MEMORANDUM

Re: 1126 E Thistle Avenue Triplex – New Construction

PLNHLC2021-00081

PLNHLC2021-00534

FIGURE 3

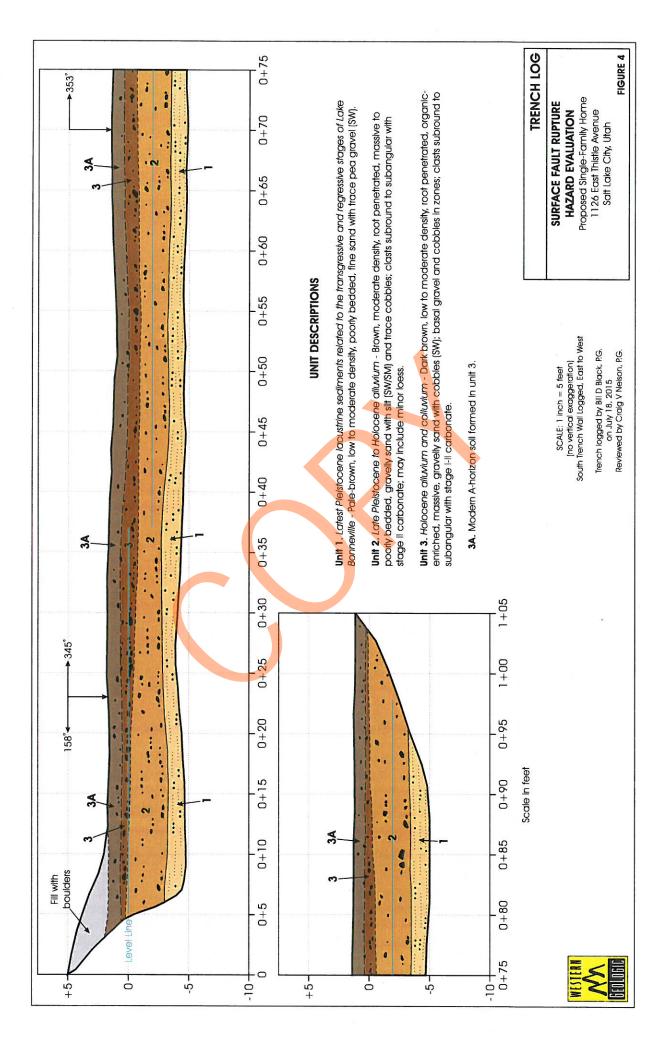
- 2. The fault trace shown on the county map (Figs 2 and 3) slopes ("dips") toward the west, suggesting the fault plane passes beneath the parcel. BUT- the rupture hazard exists only where a fault intercepts the surface or very shallow subsurface. Seismic loading is another matter- see below...

- 3. Fault rupture hazard evaluations are typically conducted by digging a trench through soils and geologic layers that are young enough to be able to show whether an "active" fault exists beneath the proposed structure (i.e. the layers had to exist before the earthquake; displacement of really old layers would be inconclusive, but disrupted younger layers would indicate a relatively young age of the earthquake(s)). The report didn't find any evidence of displacement in relatively young (Pleistocene- mid-Holocene) deposits, so they concluded that the fault rupture hazard in all but the southernmost tip of the parcel is probably low.

- 4. I agree that the southern tip was NOT covered by the fault rupture hazard investigation as summarized in this report. Not knowing the particulars of your laws, a new fault rupture evaluation would probably be required if any portion of the structure underlies this corner. However, I would add that the northwest corner was also not covered- unless the corner is outside whatever setback from a mapped fault trace (it is farther from the mapped fault), it's possible that the existing fault trace actually passes beneath this corner (maps are scale-dependent with some measure of uncertainty, which is why you need site investigations), or a second fault trace (splay) also occurs within this fault zone. [Based on the observation that a line drawn parallel to the mapped trace in Figure 3 could pass thru this corner but not be exposed by the trench.]
